**1. DETAILS OF THE DEVELOPMENT**

Ref: 21/02453/PRE  
Location: 121 Canterbury Road, Croydon, CR0 3HH  
Ward: Broad Green  
Description: Demolition of buildings and erection of a building with heights ranging between four and eight storeys to provide 93 residential units. Associated parking and landscaping, along with a public footway/cycle route through the site  
Applicant: Mr Nick Lawrence, Canterbury Road (121) LLP  
Agent: Icen Projects  
Case Officer: Mr White

*Image 10: feasibility design for emerging cycle scheme (produced by the Council 2019)*

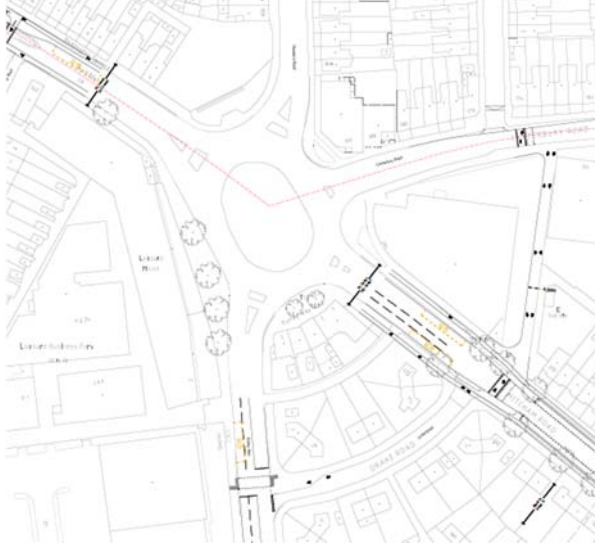
- 4.6 It should be noted that none of the above iterations allowed for the possibility of a cycle route through 121 Canterbury Road. The aim behind this is to form a

network of quiet routes around Lombard Roundabout, similar to that shown in the map below, which has a very high rate of accidents for cyclists.
